DOCUMENT 00910
ADDENDUM NUMBER FOUR (4)
March 15, 2005

PROJECT: The University of Alabama School of Law - Renovation and Addition
University of Alabama
Tuscaloosa, Alabama
UA Project No. 025-03-127

FROM: KPS GROUP, INC.
2101 First Avenue North
Birmingham, Alabama 35203

PROJECT NUMBER DRAWING NUMBER
03601-01 IR #1
SHEET 2 OF 1

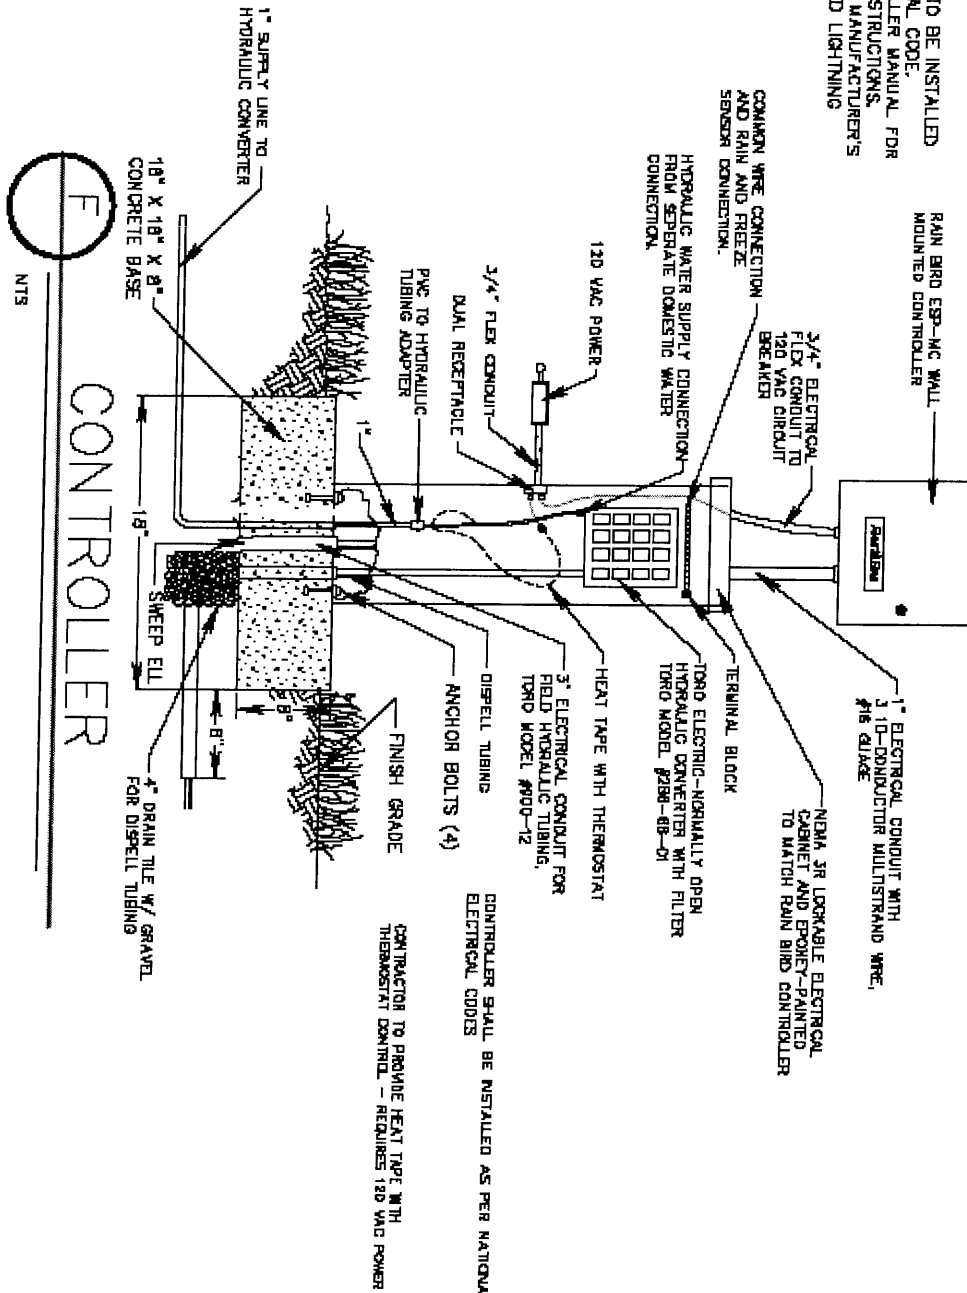
9. Irrigation Drawing Sheet I-1.01 - Irrigation Plan: Add 1" Schedule 40 PVC pipe from mainline to Hydraulic Controller for Hydraulic Supply Line per **Attached Irrigation Drawing #1**.
10. Irrigation Drawing Sheet I-2.01 - Irrigation Details: Revise Detail "F" per new **Attached Irrigation Drawing #2**.
